# Access Compliance Report Public Rights-of-Way (Curb Ramps)

Intersection ID: 7050	Main Street: CARRINGTON_DR	Cross Street: TILDEN_RD	Location: E
ADA ID: CCDCCCD48232	Ramp Type: Perp	Initial Pass/Fail: Fail	Overall Compliance: No Severity Score: 12.5

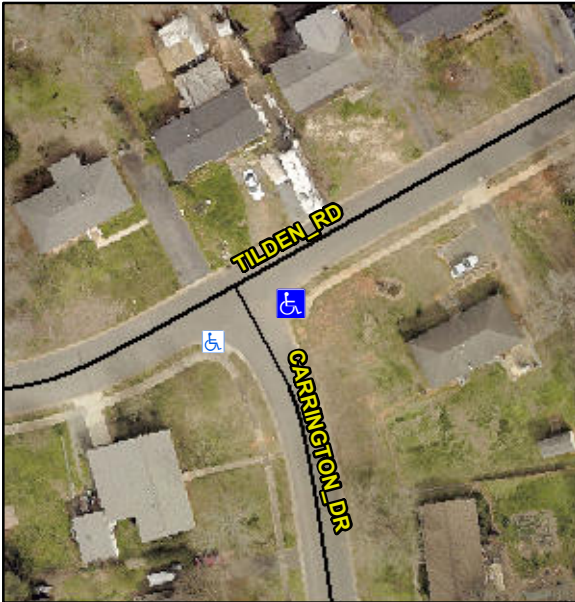
**R304.2.2**

Compliance	Description	Data	Compliance	Description	Data
N/A	Ramp Length (in)	47.0	No	Ramp Slope (%)	11.1
Yes	Ramp Width (in)	49.5	Yes	Ramp XSlope (%)	1.3
N/A	Flare Type LT	N/A	N/A	Flare Type RT	N/A
N/A	Flare Slope LT (%)	N/A	N/A	Flare Slope RT (%)	N/A
N/A	Flare Traversable LT?	N/A	N/A	Flare Traversable RT?	N/A
N/A	Landing Length (in)	N/A	N/A	DWS Provided?	N/A
N/A	Landing Width (in)	N/A	N/A	DWS Contrast?	N/A
N/A	Landing Slope (%)	N/A	N/A	DWS Length (in)	N/A
N/A	Landing X Slope (%)	N/A	N/A	DWS Full Width?	N/A
N/A	Landing Curb? (Y/N)	N/A	N/A	DWS Offset (in)	N/A
N/A	Shared Landing?	N/A			
N/A	Gutter Ponding?	Yes	N/A	Gutter Slope (%)	N/A
N/A	Gutter Lip Ht (in)	N/A	N/A	Gutter X Slope (%)	N/A
N/A	Painted X Walk1?	No	N/A	Painted X Walk2?	N/A
	X Walk 1 Direction	To W		X Walk 2 Direction	N/A
N/A	X Walk 1 Width (in)	N/A	N/A	X Walk 2 Width (in)	N/A
	X Walk 1 Slope (%)	0.5		X Walk 2 Slope (%)	N/A
	X Walk 1 X Slope (%)	2.1		X Walk 2 X Slope (%)	N/A

**Remove & Replace Entire Ramp.**
